**MONTGOMERY COUNTY HISTORIC PRESERVATION COMMISSION**  
**STAFF REPORT**

<b>Address:</b>	44 Columbia Avenue, Takoma Park	<b>Meeting Date:</b>	11/13/2024
<b>Resource:</b>	Outstanding Resource <b>Takoma Park Historic District</b>	<b>Report Date:</b>	11/6/2024
<b>Applicant:</b>	JJ Kaye (Afra Farry, Architect)	<b>Public Notice:</b>	10/28/2024
<b>Review:</b>	HAWP	<b>Tax Credit:</b>	Partial
<b>Staff:</b>			Laura DiPasquale
<b>Permit Number:</b>	1088772

**Proposal:** Partial demolition, construction of new rear addition and deck, fenestration alterations, and tree removal.

**Figure 3: 1927 Sanborn, Washington Suburban Vol. 1E, sheet 62 (left) and current aerial (right). Yellow arrows point to the original portion of the house, and red arrows to the existing non-historic addition. The 1959 Sanborn shows the same footprint as the 1927 Sanborn.**

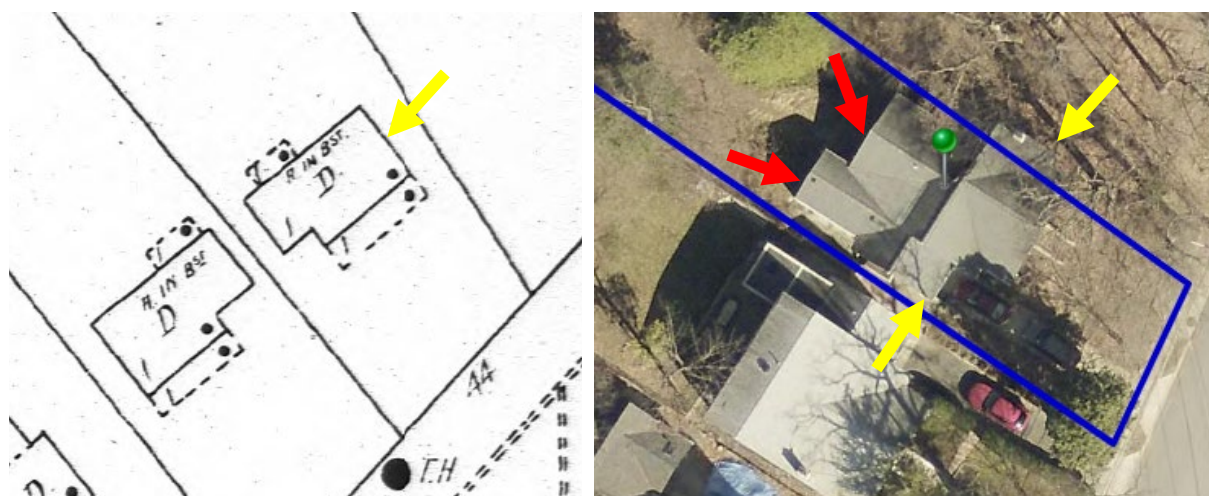
The proposed addition would modify and extend an existing non-historic rear addition to the property, constructed after 1959. The proposal utilizes two existing walls of the non-historic rear addition at the southwest corner, adding additional fenestration to these elevations. To the northeast, the application

proposes to remove the existing rear deck and walls and extend the footprint of the addition to the rear. The northeastern wall plane of the new addition would be set in from the existing plane of the historic main block of the house. A new gable roof would be added to cover the rear addition, intersecting the rear slope of the main block's gable roof just below the ridge. The eaves of the proposed addition would extend beyond the wall planes, to match those of the historic house. The addition would be clad in smooth Hardie lap siding and feature Andersen 400 series vinyl-clad wood windows with similar pane configurations to those of the historic house. A new wood deck with 2-inch by 2-inch spindles and a flat top drink rail would extend from the rear of the proposed addition. The applicants note the railing may be painted white to match the house trim.

**Figure 5: Existing south elevation (left) and proposed south elevation (right).**

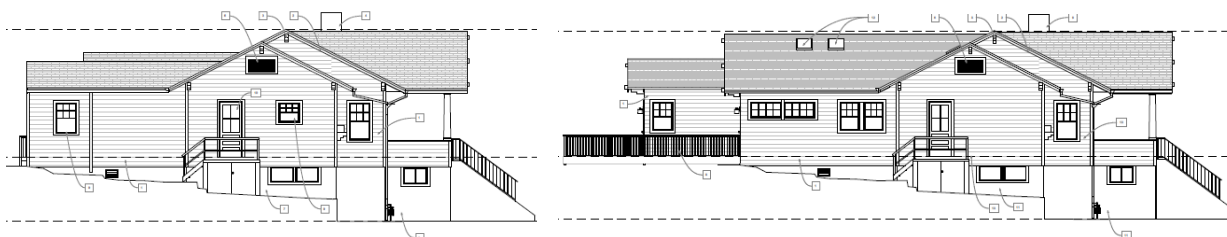
Staff finds that the proposed addition will not substantially alter the exterior features of the historic resource and is compatible in character with the historic resource and district, as laid out in Chapter 24A-8(b)(1) and (2), and that the placement of the addition at the rear, in a location that will be minimally visible from the public right-of-way, is in keeping with the *Design Guidelines*. Staff also finds that the proposed addition is in keeping with *Standards 2 and 9* because it does not remove historic fabric that characterizes the property, and is compatible with the historic in scale, massing, materials and features with the historic resource, and, if removed in the future, would leave the essential form of the historic building unimpaired, satisfying *Standard 10*. The Secretary of the Interior's *Guidelines for Rehabilitating Historic Buildings*, which extrapolates on the more succinct *Standards for Rehabilitation*, provides guidance on new exterior additions and related new construction, explaining that "generally, a new addition should be subordinate to the historic building. A new addition should be compatible, but differentiated enough so that it is not confused as historic or original to the building."<sup>1</sup> Staff finds that the design of the addition, which does not rise past the ridge of the existing roof and is set in from the sides of the historic house, allowing the original house form to be readily apparent, creates an addition that is subordinate to and differentiated from the historic building, in keeping with the *Guideline for New Exterior Additions and Related New Construction*.

Figure 9: Survey of proposed trees for removal, submitted by applicant (left), and photo of rear yard and trees to be removed (right).

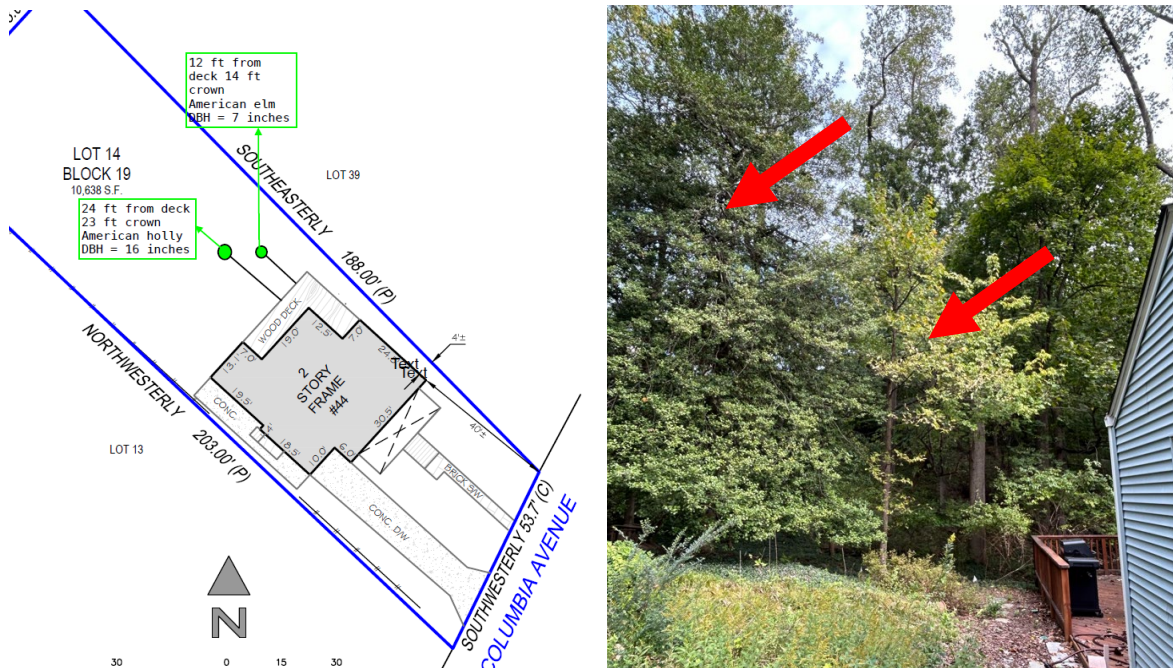
Along with the construction of the addition, the applicants propose to remove two trees in the rear yard with diameters greater than 6 inches in width—a 16-inch American Holly and a 7-inch American Elm. Other smaller shrubs are proposed for removal, but do not fall under the HPC’s jurisdiction. Staff supports the proposed removal, finding that, given the diameter and location of the trees, they do not constitute important mature trees and are not established visual features of the resource or district.

**Figure 12:** Existing south elevation. The two windows to be removed are circled in red: one on the existing non-historic addition (left) and one on the historic building (center).

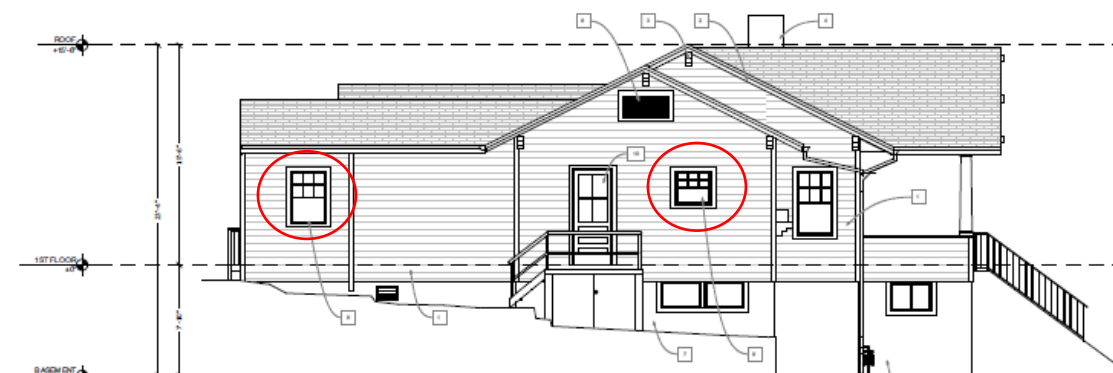
On the south elevation of the historic building, the applicants propose to eliminate one small side window. Staff notes that, while the wood frame of the window appears to be original, the existing one-over-one sash does not. Likewise, the existing aluminum siding cladding the exterior of the main house is not original. The applicants do not identify the patching material to be used to repair the opening, but staff notes that existing aluminum siding from the rear elevation could be repurposed. Staff does not find that the existing

window is a character-defining feature or that its removal would constitute a substantial alteration and recommends approval, provided the opening is patched to match the surrounding aluminum siding material and that the new or repurposed siding matches the dimensions, material, and appearance of the existing siding and is toothed in to the surrounding siding.. Staff notes that, alternatively, the existing aluminum siding could be removed and the original underlying material restored and the opening patched to match the original material. Restoration of the original cladding material would be eligible for County historic preservation rehabilitation tax credits.

The applicants also propose to remove one existing window on the south wall of the existing non-historic rear addition that is being incorporated into the new addition. New compatible fenestration would be added to this elevation.

1. The original front door must be retained or, if the severity of deterioration is such that it cannot be repaired, replaced in kind. HP Staff will make the final determination if the door cannot be repaired, and will review the specifications for a replacement door.
2. The east altered window opening must be patched to match the surrounding aluminum siding and that the new or repurposed siding must match the dimensions, material, and appearance of the existing siding and be toothed in to the surrounding siding, and the plans updated to note these materials. The applicant also has the option to remove the existing aluminum siding and restore the underlying material, and patch the opening to match the original underlying material.
